REMARKS/ARGUMENTS

The present application is for a device named “disconnecting circuit breaker” providing the equivalent safety function as a combination of one circuit breaker and one or two disconnecting switches for high tension switch gear. Traditionally, circuit breakers of this type were required to have separate disconnecting switches positioned adjacent to the circuit breaker to provide assured safety to technicians performing maintenance on such systems. The present invention eliminates the need for such disconnecting switches by providing a circuit breaker which can be electrically and mechanically interlocked in the open position, and provides visible indicators of this state to those who may need to ascertain the status of the breaker. Thus the present invention provides added safety while eliminating the need for a separate disconnecting switch.

Fig. 3

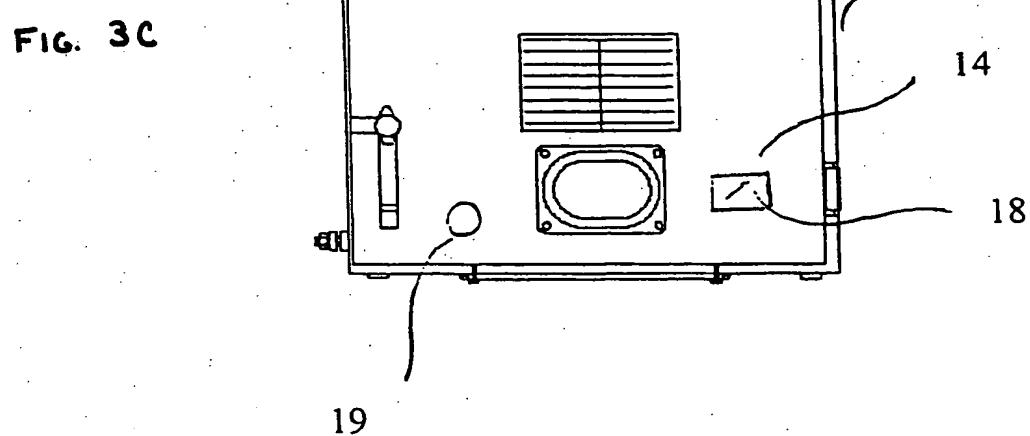
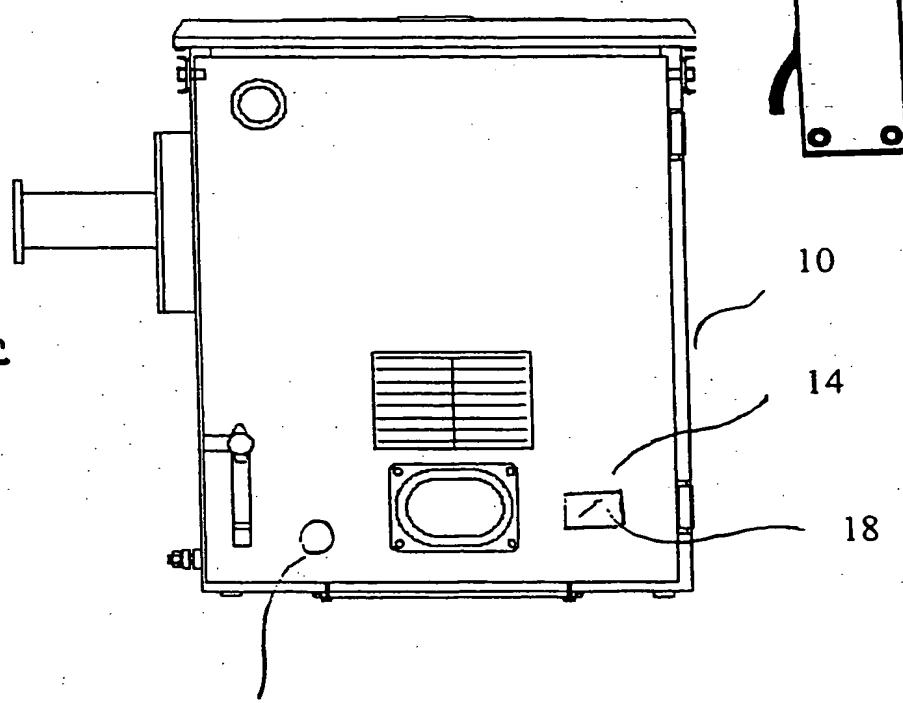
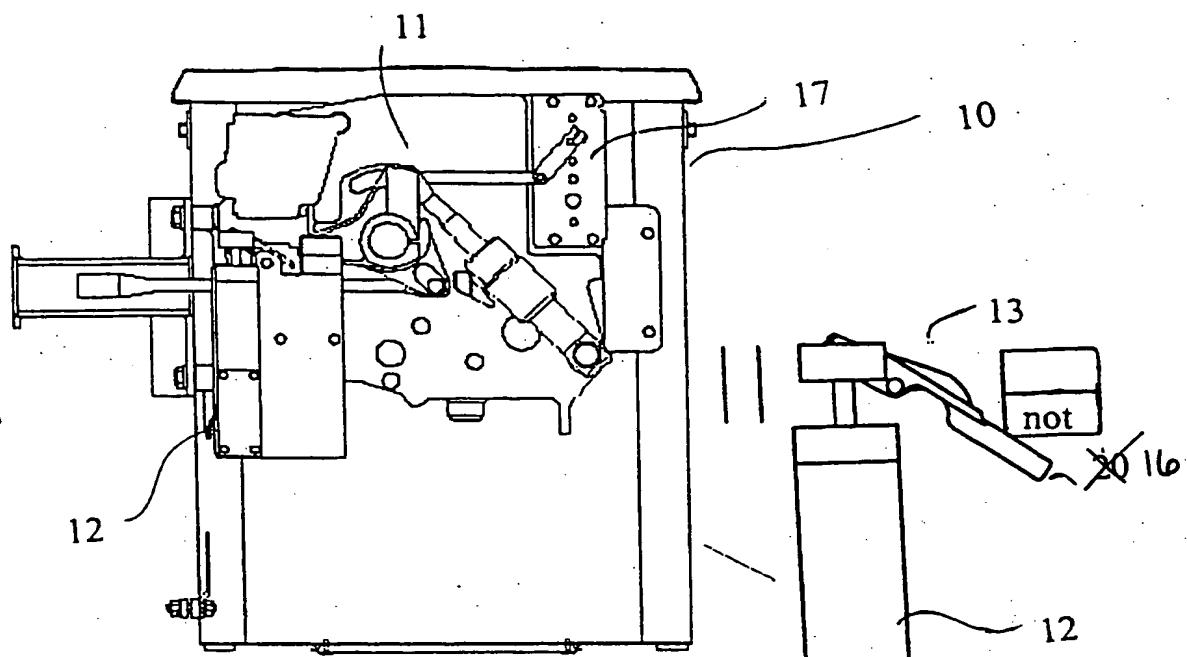
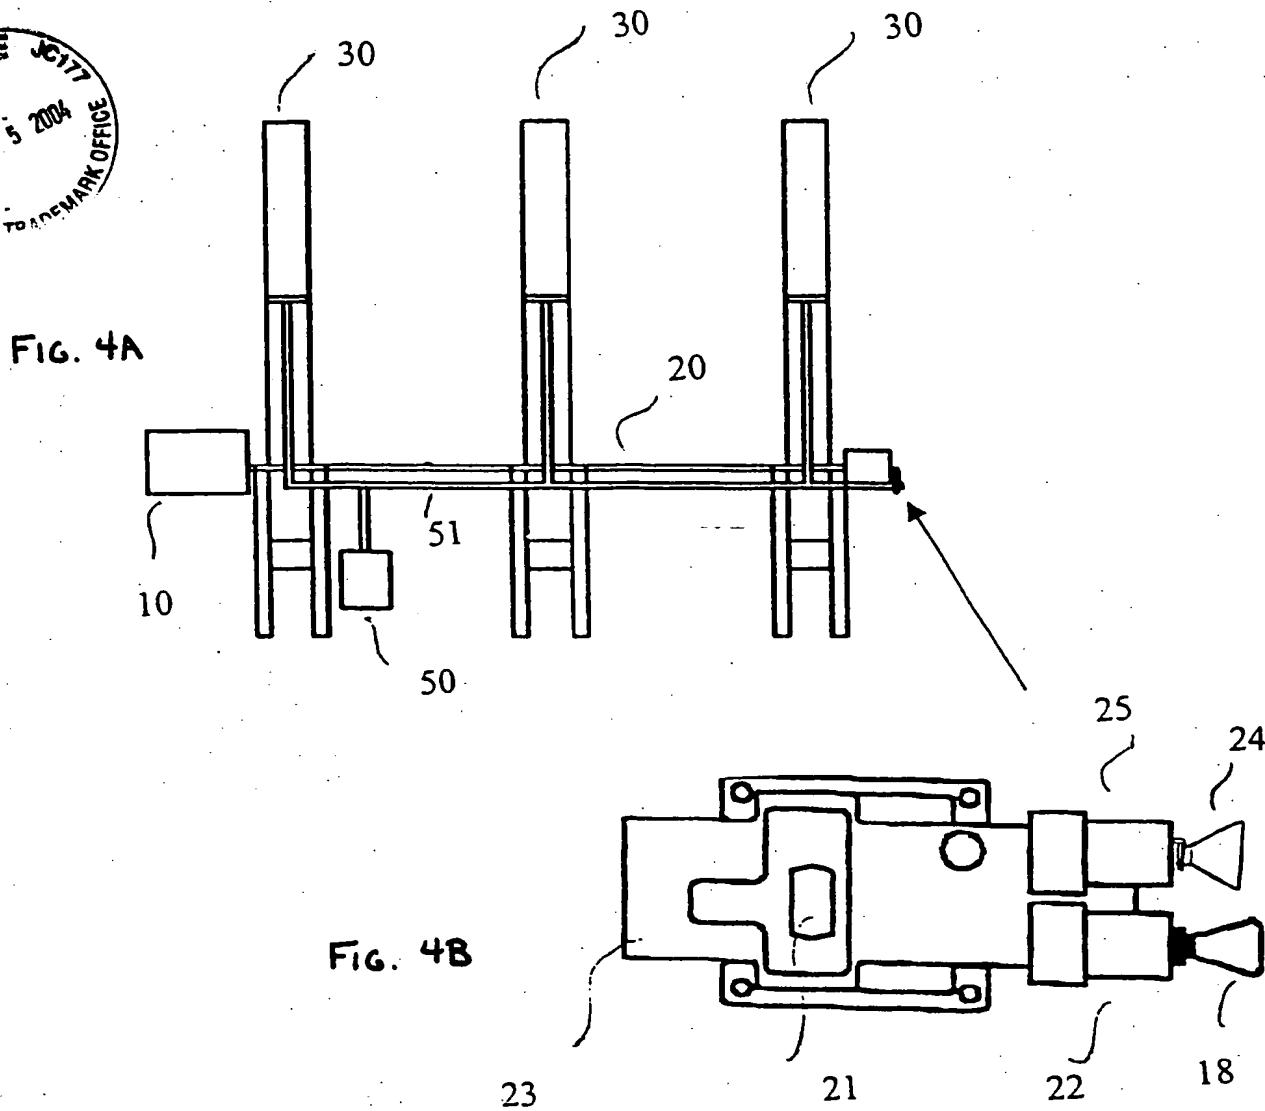
Figures 3, 4 and 6 stand objected to as including multiple figures. Accordingly, amended figures have been supplied. With regard to reference numeral 16 as used on page 3, line 31, the Applicants thank the Examiner for bringing this typographical error to their attention and confirm that reference numeral 20 of figure 3b should in fact read 16.
